Roller Assembly 549AS10

Introducing Our New Roller Series

549AS10 Roller Assembly

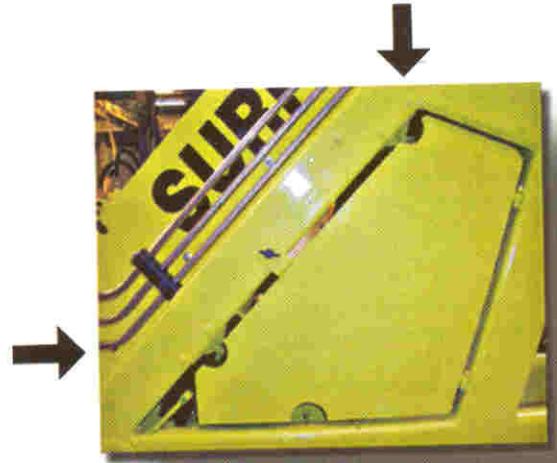
1. Our new improved Roller Assemblies are greasable and can be accessed easily from outside of the machine.

2. They have an increased diameter that allows for a greater wearing surface.

3. Their increased width supports both side links of each chain. This adds greater support and allows the chain to run more smoothly.

4. They are interchangeable with all old roller. The new Roller Assemblies can be attached using the same nuts, bolts and lock washers for fastening to the side frame. Small adjustments to the side shield may be necessary to make room for the grease fitting.

5. Most importantly, the new Roller Assemblies are designed with adjustable internal components to reduce internal wear. To adjust the Roller Assembly:

- a. Remove Roller Assembly from machine**
- b. Remove outer snap ring and outer cover**
- c. Remove inner snap ring**
- d. Add required shims. Make sure roller turns freely. Do not over-tighten**
- e. Reassemble and grease as required**
